STAFF REPORT
COMMUNITY DEVELOPMENT DEPARTMENT

HEARING DATE: November 6, 2024
 TO: Mayor & City Council
 FROM: Bill Parsons, Current Planning Supervisor
 208-884-5533
 SUBJECT: The Gateway at Ten Mile PP, CUP
[H-2024-0010](#)
 LOCATION: NEC of W. Franklin Rd. & N. Ten Mile Rd., in the West 1/2 of the SW 1/4 of Section 11, Township 3N., Range 1W. (Parcel: S1211336065)

Preliminary plat (PP) consisting of 31 buildable lots 3 common lots on 38.99+/- acres of land zoned C-G and R-40 for The Gateway at Ten Mile; and a Conditional use permit (CUP) for a multi-family development containing a total of 390 residential dwelling units in the R-40 zoning district.

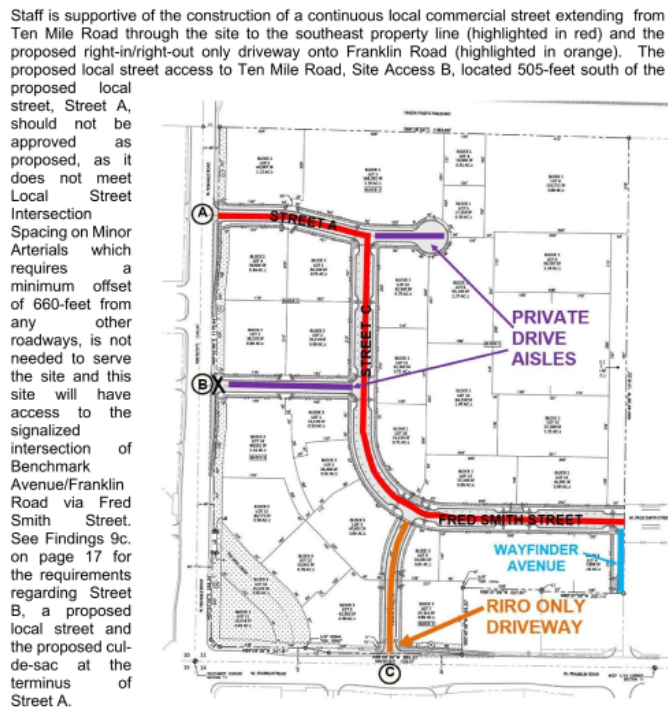
Two (2) access driveways are proposed via W. Franklin Rd. – one (1) right-in/right-out only (Private Street A), 565-feet east of Ten Mile Rd. and one (1) full-access, east of Ten Mile Rd. (Wayfinder Avenue -future collector to be built). Upon dedication of the required right of way by third parties, the Applicant shall construct half plus twelve feet of the future collector street adjacent to the property's southeast corner, as shown on the preliminary plat. ***The City supports the additional access to Franklin Road because the completion of the collector roadway is contingent upon the owners of the adjacent properties to the southeast (parcels S1211336300 & S1211336401) ACHD has approved the full access for the future collector to be built as a full access and the right-in/right-out only as proposed***

with Private Street A. Staff recommends depicting Private Street A as a drive aisle on the plat because it does not meet the private street standards outlined in UDC 11-3F-4.

Two (2) access driveways are proposed via S. Ten Mile Rd. – two (2) full-accesses, 825-feet north of Franklin Rd. (Public Street B) and one (1) 1,330-feet north of Franklin Rd. (Public Street A). **Where access to a local street is available, the Applicant shall reconfigure the site circulation plan to take access from the local street (Public Street C) in accordance with UDC 11-3A-3. Staff recommends removing the access for Public Street B on Ten Mile Road from the plat limiting the number of access points on a busy arterial street near an intersection per UDC 11-3A-3. The proposed commercial lots can take access from Public Street C.**

Other than the accesses specifically approved with this application, direct lot access is prohibited to Franklin Road and Ten Mile Road and should be noted on the final plat (refer to figure below).

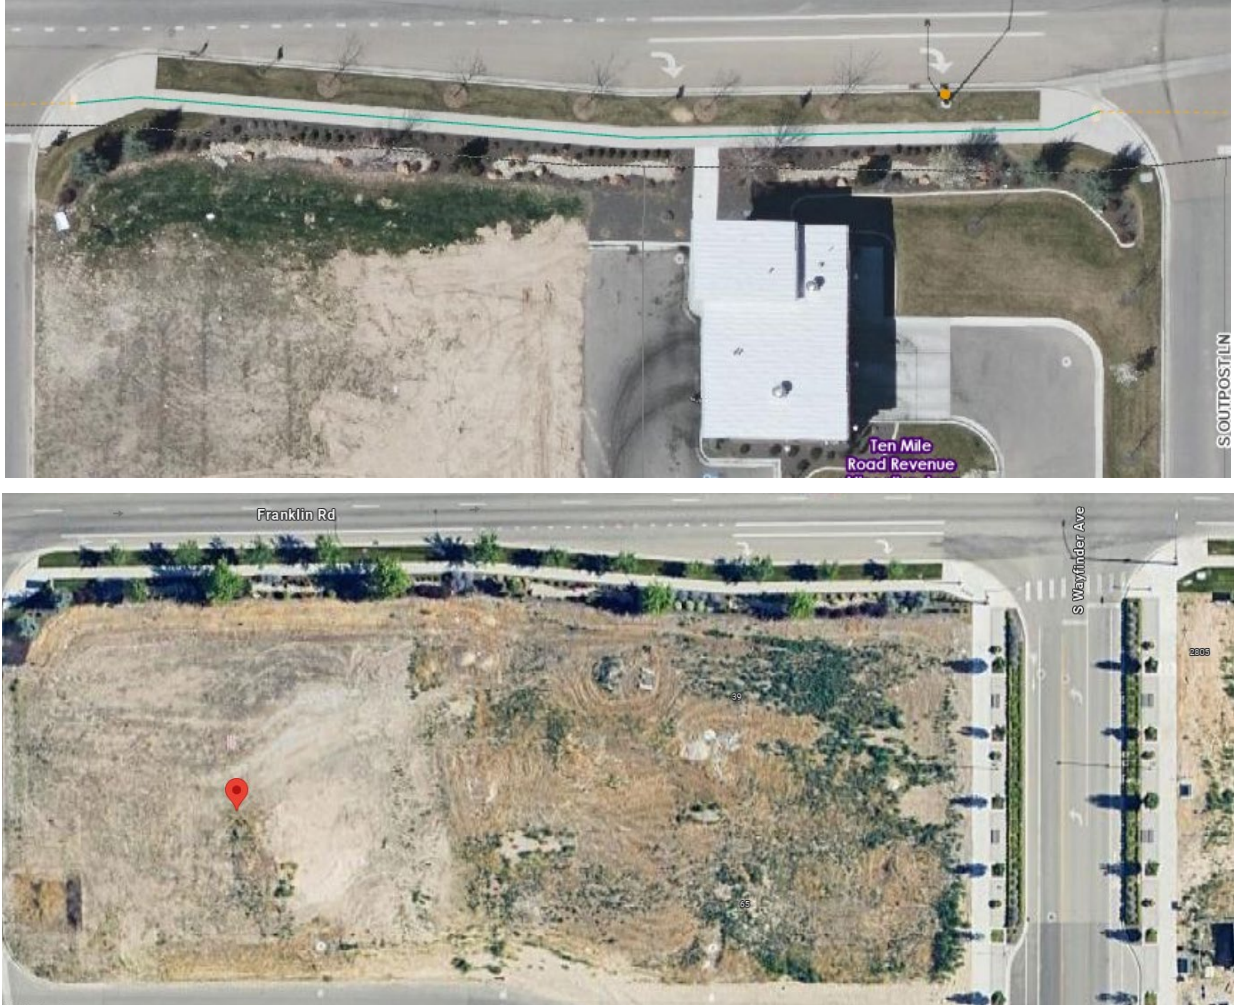
There are no multi-use pathways depicted on the Pathways Master Plan for this site. Walkways are proposed throughout the site for pedestrian access and interconnectivity. A 7-foot wide attached sidewalk exists along Franklin Rd. abutting the site within the influence area of the intersection transitioning to a 5-foot wide detached sidewalk for the remaining site frontage. **A 7-foot wide attached sidewalk exists along N. Ten Mile Rd., which should be a minimum 6-foot wide detached sidewalk, separated from the curb by a minimum 8-foot wide tree lawn/parkway, consistent with Street Section A in the TMISAP (see pg. 3-20). A 10-foot wide pathway is preferred along Franklin Rd. and Ten Mile Rd. based on ACHD's adopted Livable Streets Performance Measures but not required. Staff is not requiring the Applicant to replace the existing 7-foot wide attached sidewalks and 5-foot wide detached sidewalk that run along both arterials.**

The Applicant is proposing what appears to be 6-foot wide sidewalks along both sides of W. Fred Smith Street and Public Street C. **Staff recommends that the Applicant construct 10-foot wide detached pathways along both sides of these streets in accordance with ACHD's adopted Livable Street Performance Measures and UDC 11-3A-5.**

West Ada School District (WASD) recommends the addition of a micro-path from the plaza area between Street A and Street B to the sidewalk along Ten Mile Road. This location would be a prime location for a bus stop.
